REFERENCE:	Nova Bus Manuals
SECTION:	09: Hydraulic system, T-Drive
RS N°:	MQR 7621-549
EFFECTIVE IN PROD.:	L765 (2013JN)

SUBJECT:	Hydraulic tank bushing
JUSTIFICATION:	Hydraulic tank bushing is cracking

Figure 1 - New Hydraulic Reservoir Anchor Hardware

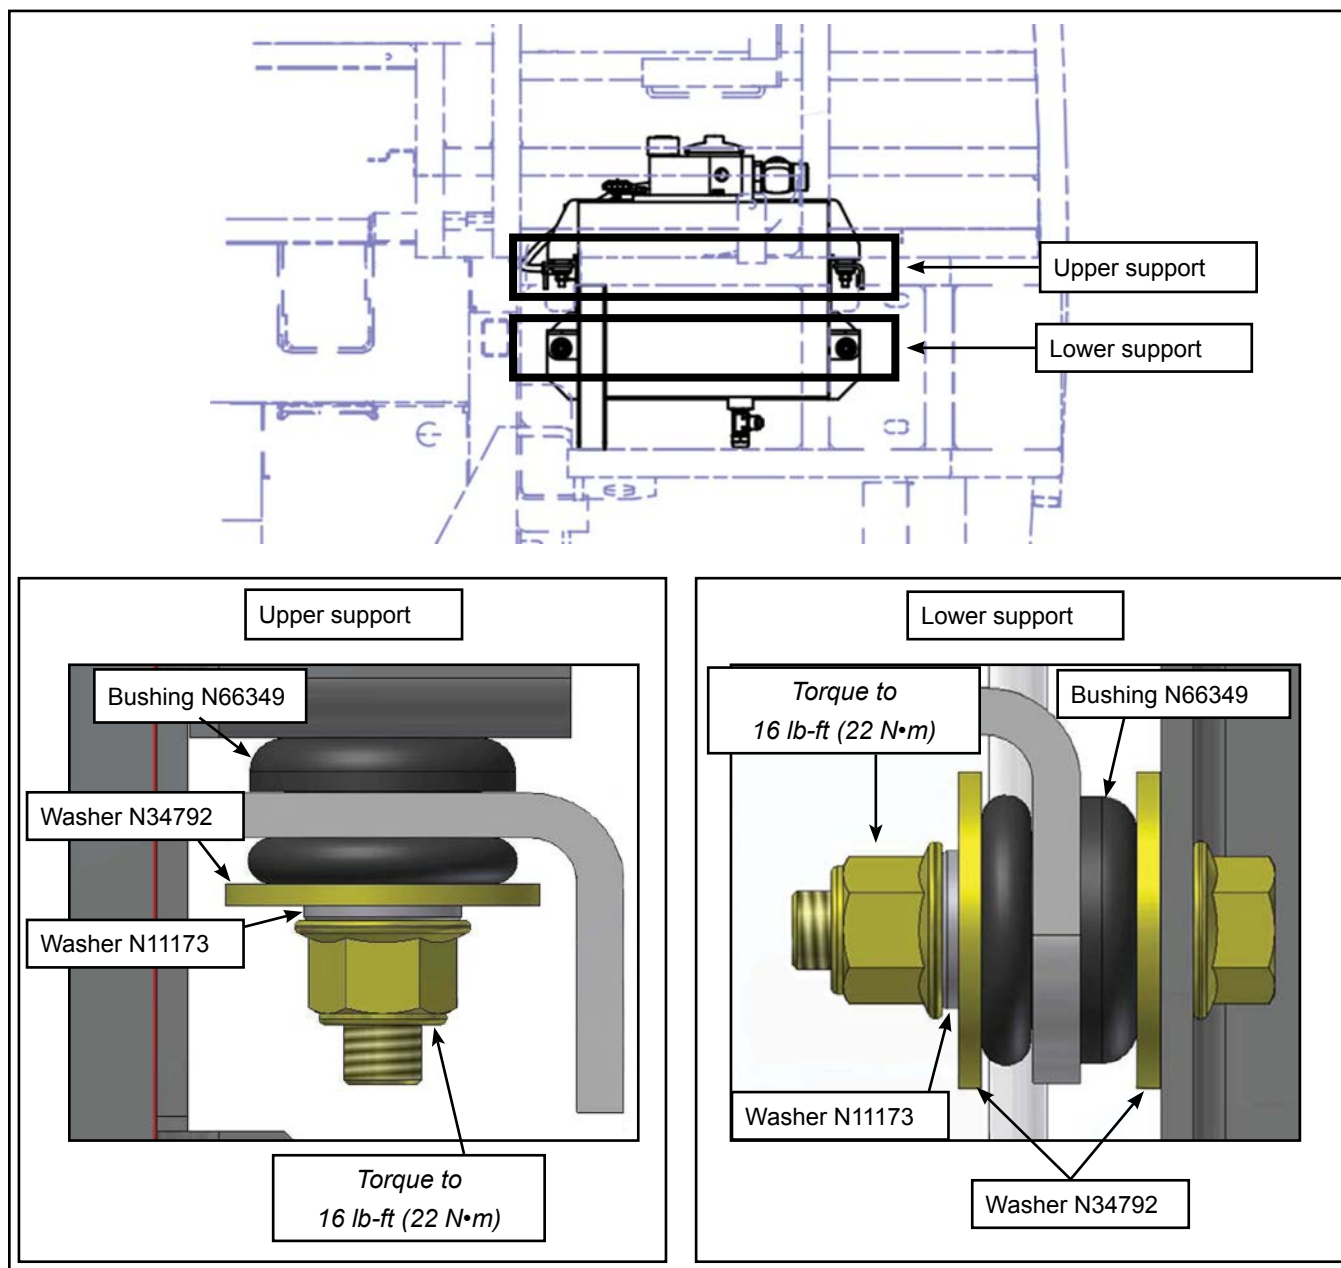
LEVEL	DESCRIPTION	DIRECT CHARGES		TIME
		LABOUR	MATERIAL	
1	Replace the hydraulic tank bushing with new bushing N66349	Nova Bus	Nova Bus	20 min
2	–	–	–	–

- 1.1. Open the rear engine access door.
- 1.2. Install a mobile support under the hydraulic reservoir.
- 1.3. Remove the anchor bolts and hardware (bushing and washer) from the hydraulic reservoir. Retain the bolts and nuts.
- 1.4. Install two oversized washers N34792, one washer N11173 and one bushing N66349 on each lower support and fix them with the retained bolts and nuts. See Figure 1 for the position of the hardware and the torque value.
- 1.5. Install one oversized washer N34792, one washer N11173 and one bushing N66349 on each upper support and fix them with the retained bolts and nuts. See Figure 1 for the position of the hardware and the torque value.
- 1.6. Remove the mobile support and close the rear engine access door. ❖
